ADDENDUM NUMBER 1

GRANT PARK LIFT STATION REPLACEMENT

Project Number: V029-13808

Date of Addendum: November 10, 2014

C603

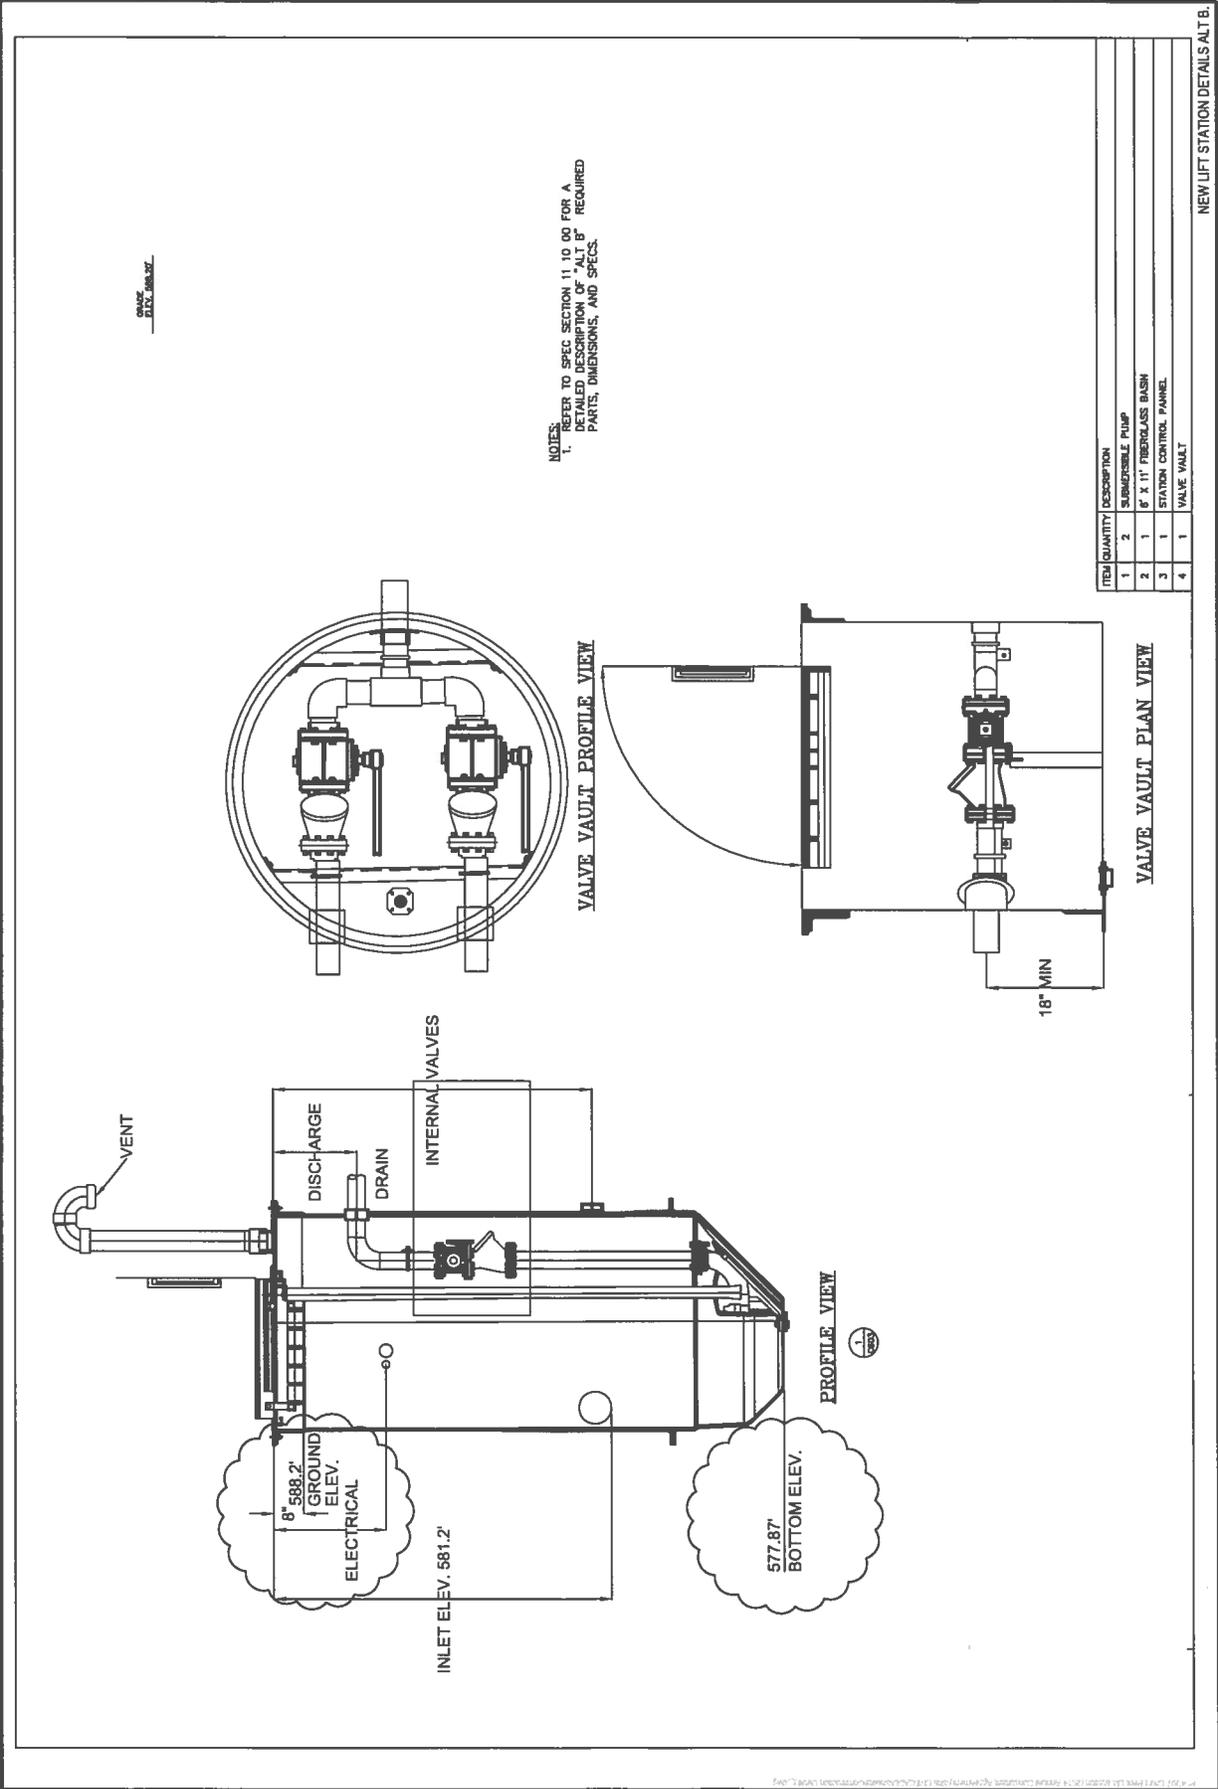
Question 1.) Regarding Alternative Bid Item B: Will you accept a 11'-0" tall fiberglass lift station, completely prepackaged with Flyght pump.

Answer: Yes , please see revised drawing C603.
